EXPANSION AND ALTERATIONS TO WEST SHORE MIDDLE SCHOOL

S/P+A Project No. 14.278

DATE: November 11, 2016

The following changes to the Drawings and Project Specifications shall become a part of the Drawings and Project Specifications; superseding previously issued Drawings and Project Specifications to the extent modified by Addendum No. 1.

Date: 8/18/2016
Scale: AS NOTED
Drawn By: PEJ
Project Number: 14.278
Drawing Number: A06.1

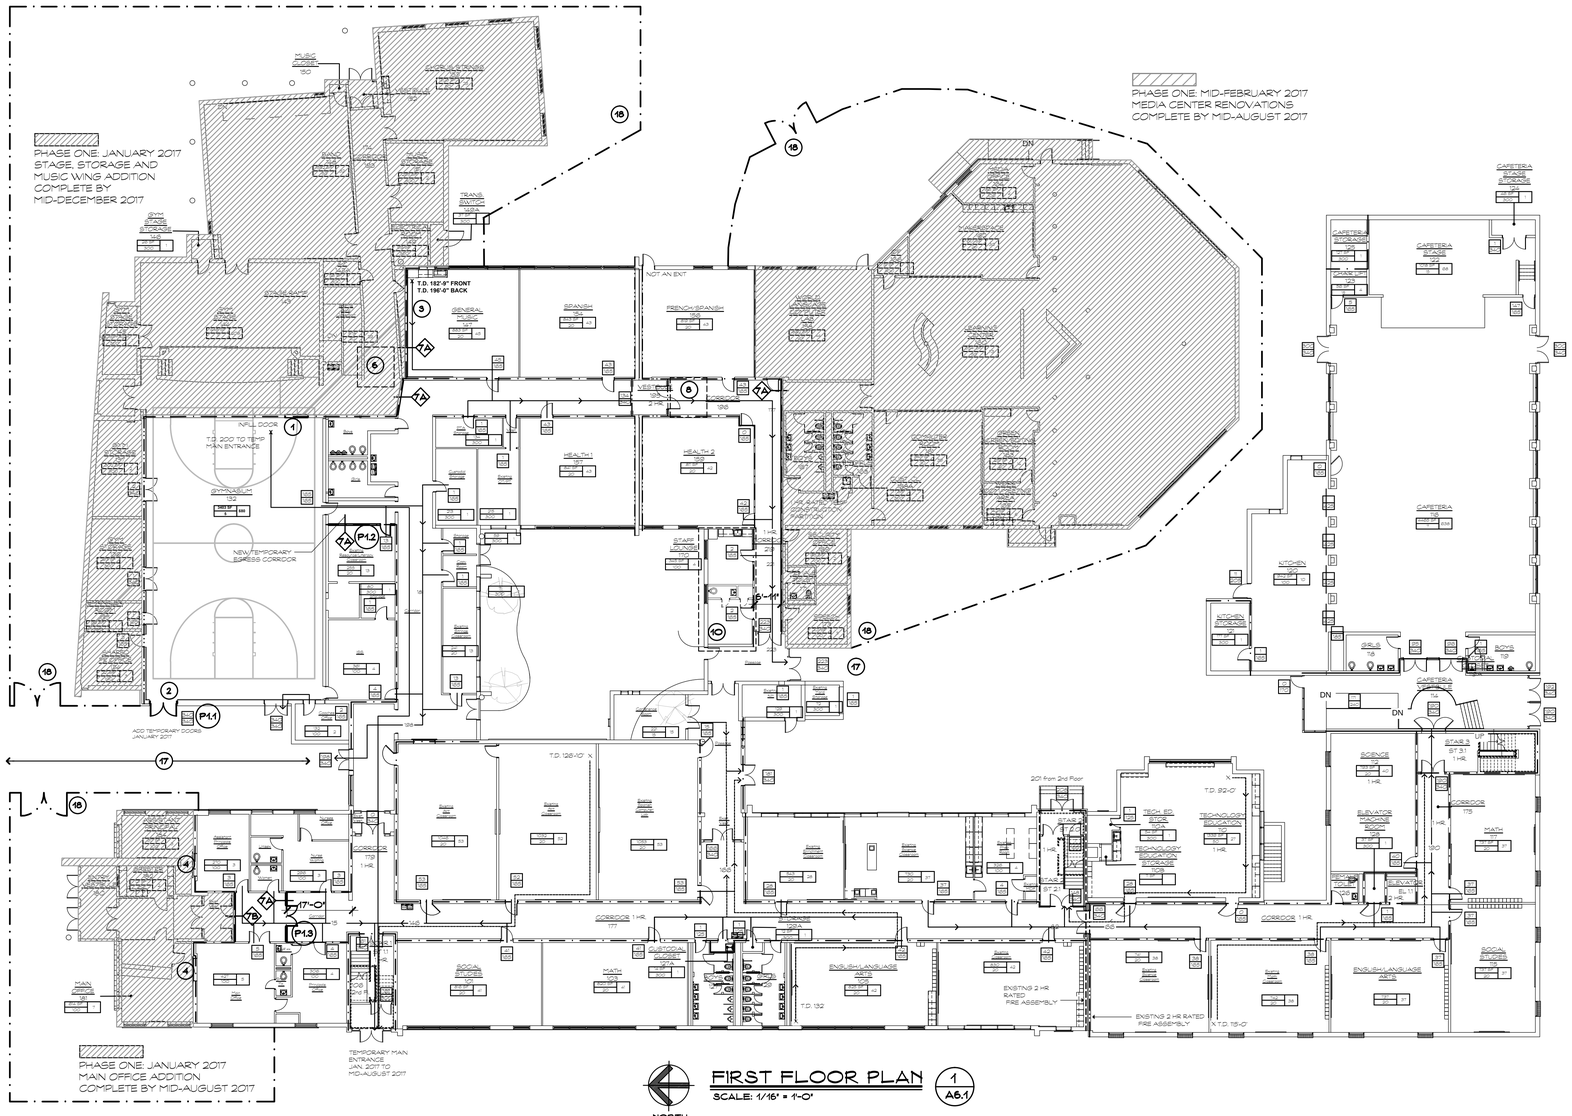
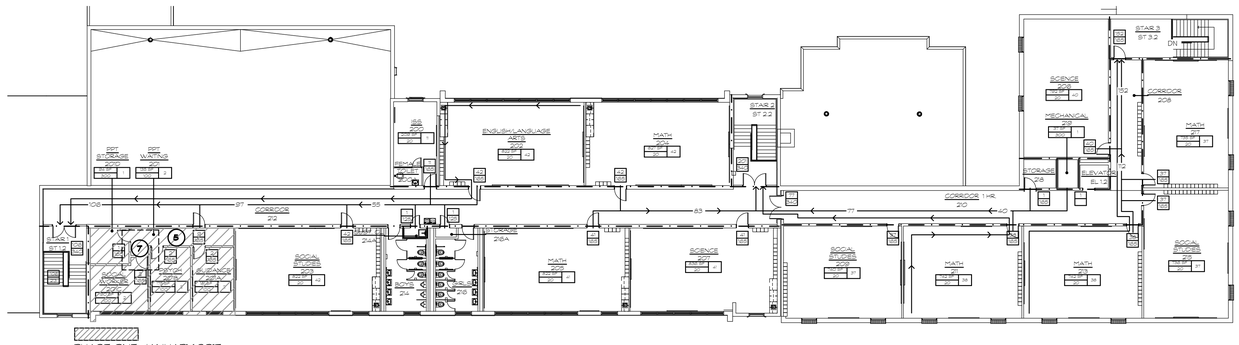
ADD: C. Heavy-Duty Doors and Frames: SDI A250.8, Level 2. Doors P1.2 (single leaf) and P1.3 (double leaf), locations as indicated on Drawing A06.1 "Construction Phasing Plans Phase One, January 2017.

ADD: C. Extra-Heavy-Duty Doors and Frames: SDI A250.8, Level 3. Double Leaf Door P1.1, location as indicated on Drawing A06.1 "Construction Phasing Plans Phase One, January 2017.

Drawing Number: A103

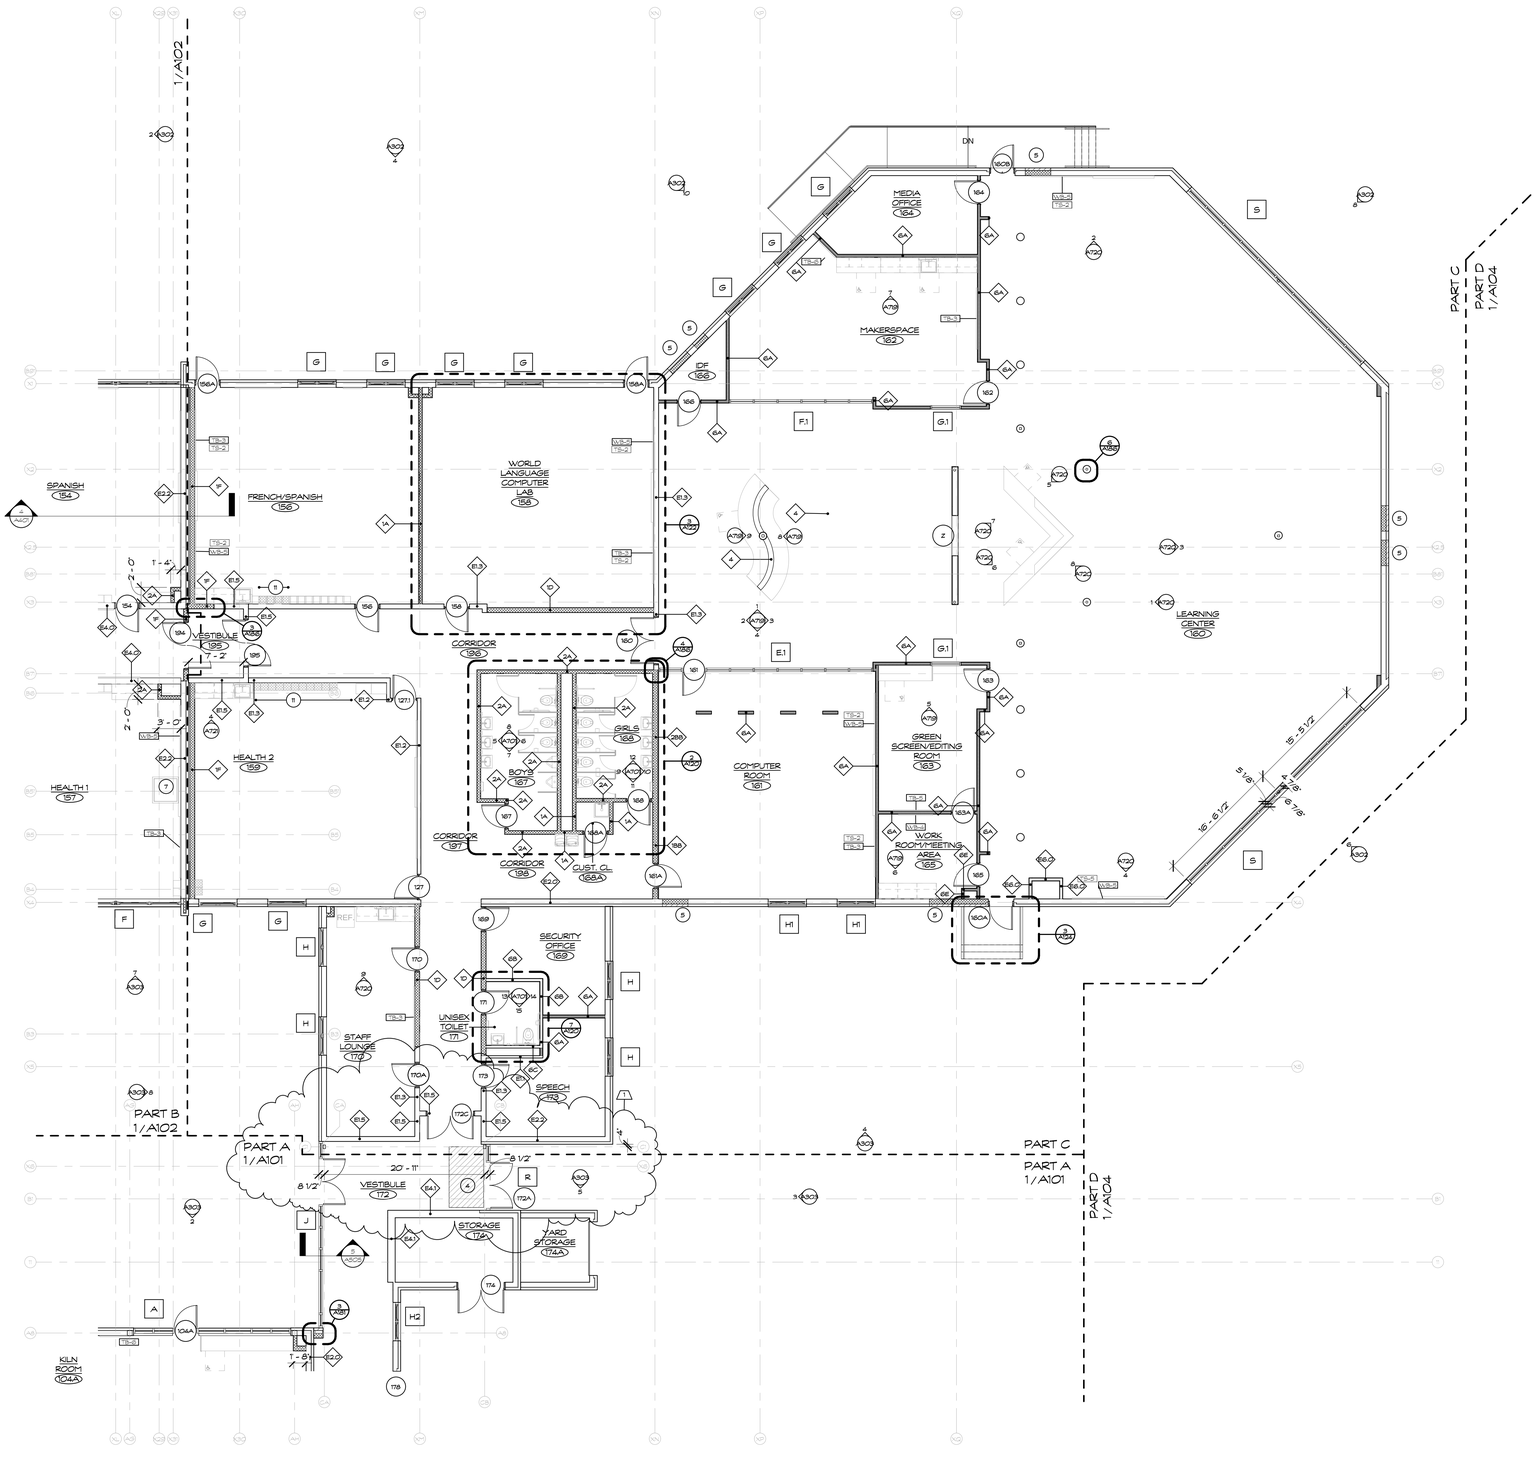
Line	Question	Answer
1	Please provide HM frame elevation type H for tag# 172.	172 IS FRAME ELEVATION H.1
2	Please provide HM frame elevation type(s) for tag# 174 and 178.	FRAME TYPE B SEE REVISED DWG. A910
3	Please advise what tag#'s HM frame elevation types E.1, F.1, G.1 and H.1 should be assigned to.	DOORS ARE ALL TAGGED IN PLAN. E.1 IS DOOR 161 H.1 IS DOOR 172, F.1 AND G.1 HAVE NO DOORS AND ARE HM FRAMES WITH GLASS ONLY LOCATED IN MEDIA ON DWG. A103
		REVISED A910 ATTACHED TO ADDENDUM

Drawing Title: Door Schedule
State Project Number: TMP-084-JLGB
Date: 8/18/2016
Scale: As indicated
Drawn By: Author
Project Number: 14.216
Drawing Number: A910

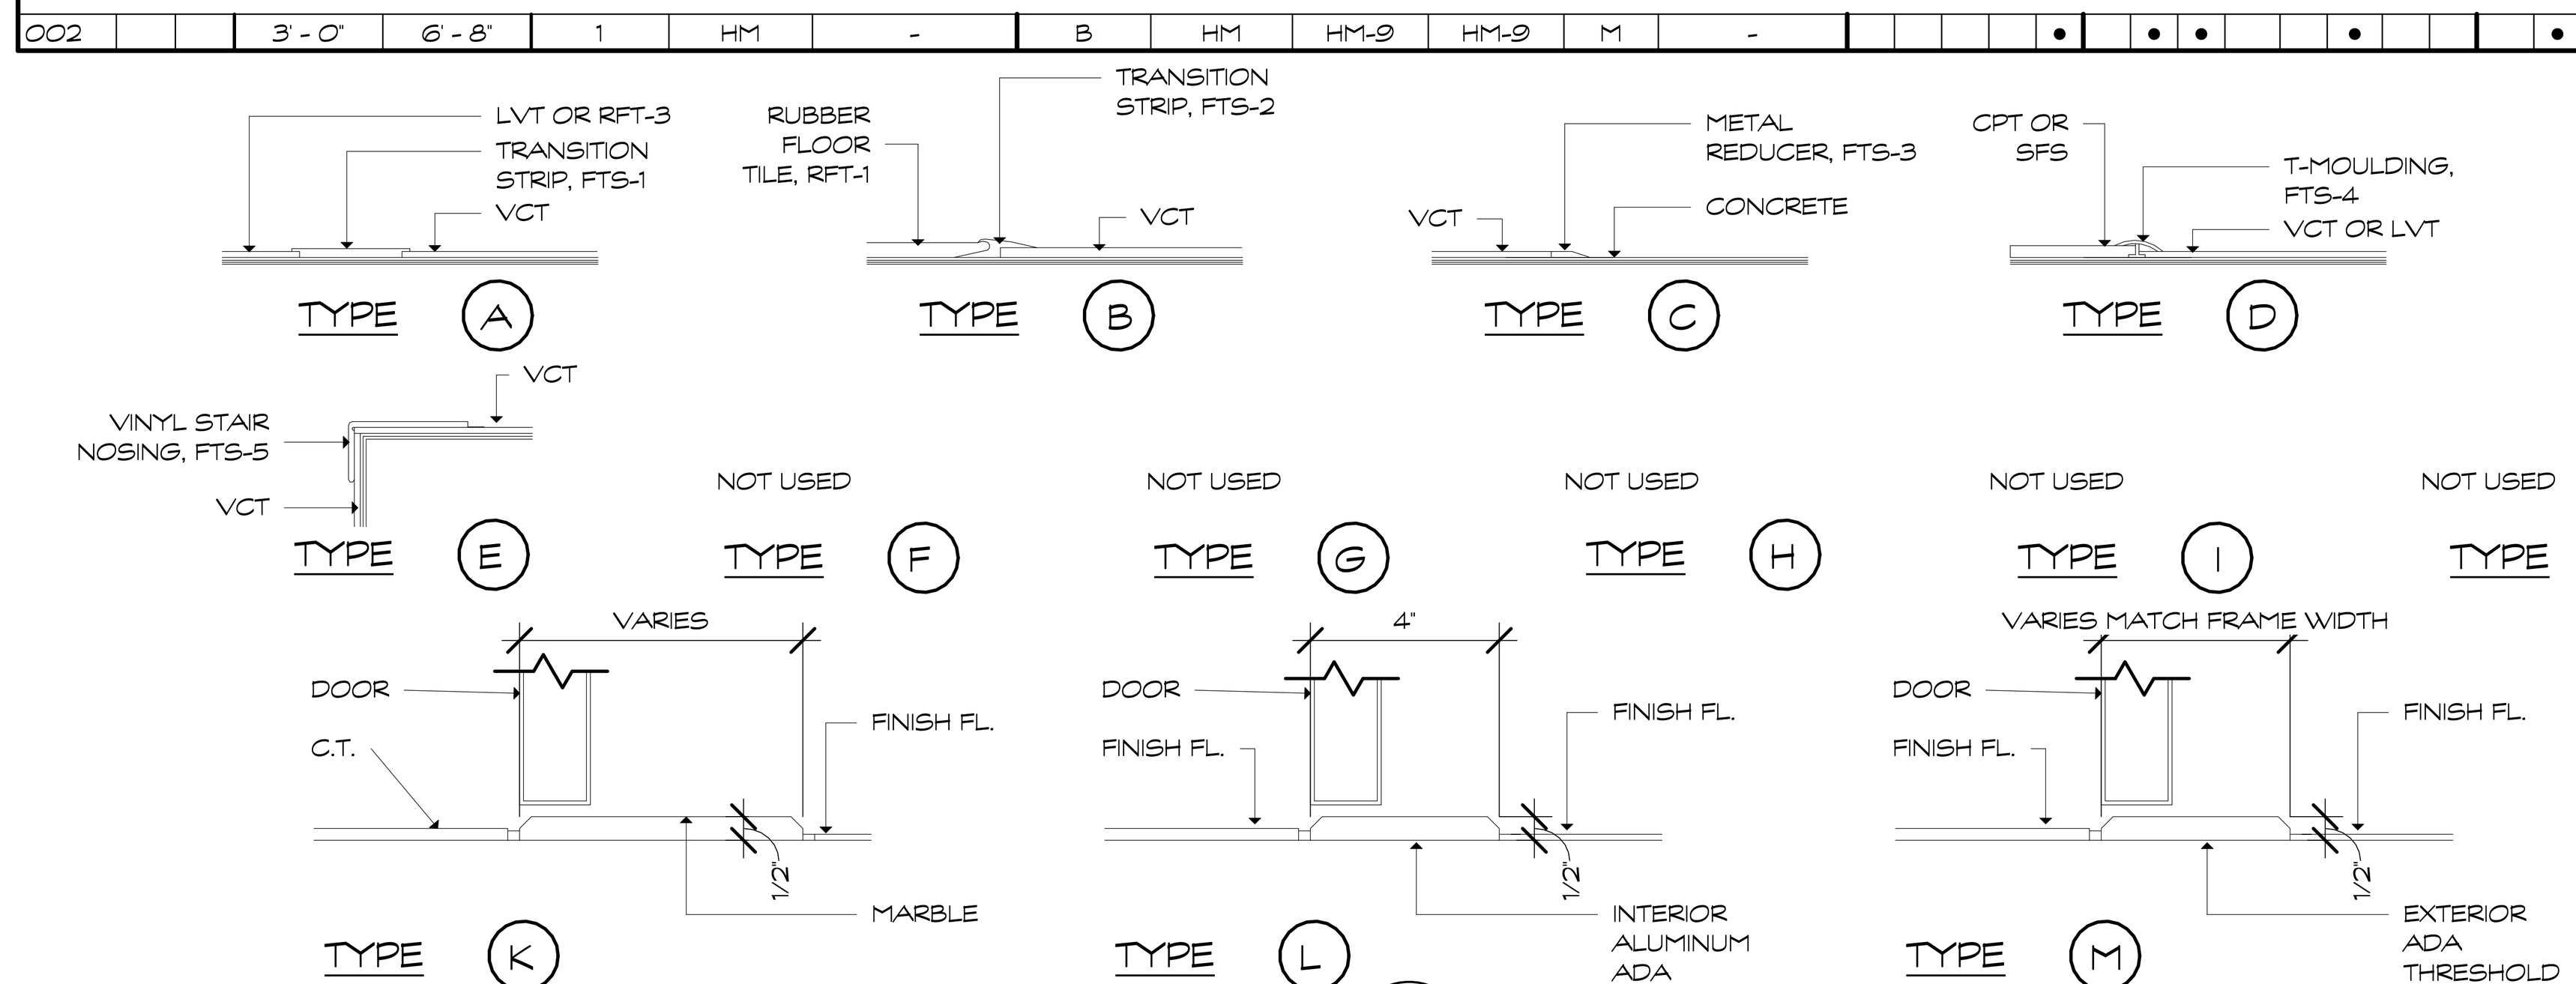
Line	Question	Answer
1	Are openings 102D, 104A, and 133C actually aluminum frames and doors and not hollow metal as indicated on the door schedule ?	
	yes, 102D, 104A, and 133C Are Aluminum Doors
